**SERVICE BULLETIN**

**SB05-11**

**SUBJECT: PIPER SERVICE BULLETIN 1157A**

**SUBJECT:** FIELD UPGRADE OF PRESSURIZED MAGNETOS & TACHOMETER SENSOR ASSEMBLIES

Figure 1  
Magneto Sensor Assembly

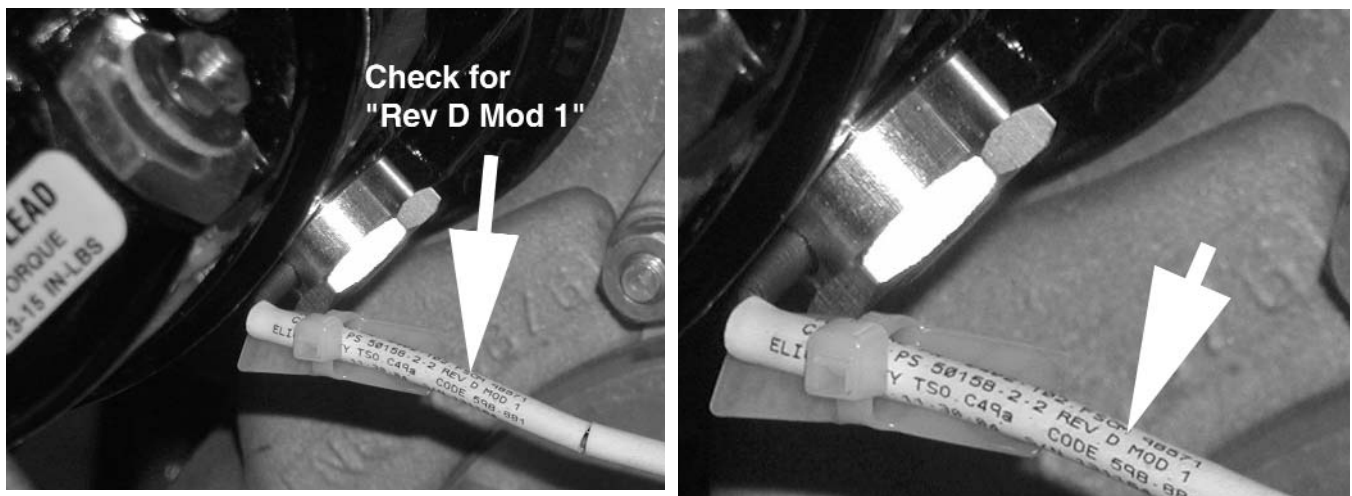
Two improvements to the sensors, which have eliminated the inadequate air supply flow, are: (1) an increased bleed port from .015 inches to .025 inches; and, (2) removing the filter element from the bleed port. To distinguish between the old and the modified Hall Effect Magneto Sensor Assemblies, Teledyne has identified the new sensor part number as 0402-102 Mod 1.

6. Check the tachometer sensor assembly for correct part number on the sensor cable, PS 50158-2-2 Rev D Mod 1. See Figures 1 and 2 for identification.
7. Replace the tachometer sensor if the tag does not have Rev D Mod 1 as illustrated in Figure 2.

9. On all affected aircraft if the tachometer sensor is not labeled PS 50158-2-2 Rev D Mod 1 that tachometer sensor must be replaced with a 598-881 labeled PS 50158-2-2 Rev D Mod 1. Tachometer sensors that require replacement will be replaced free of charge per the limitations of the SUMMARY section of this bulletin.
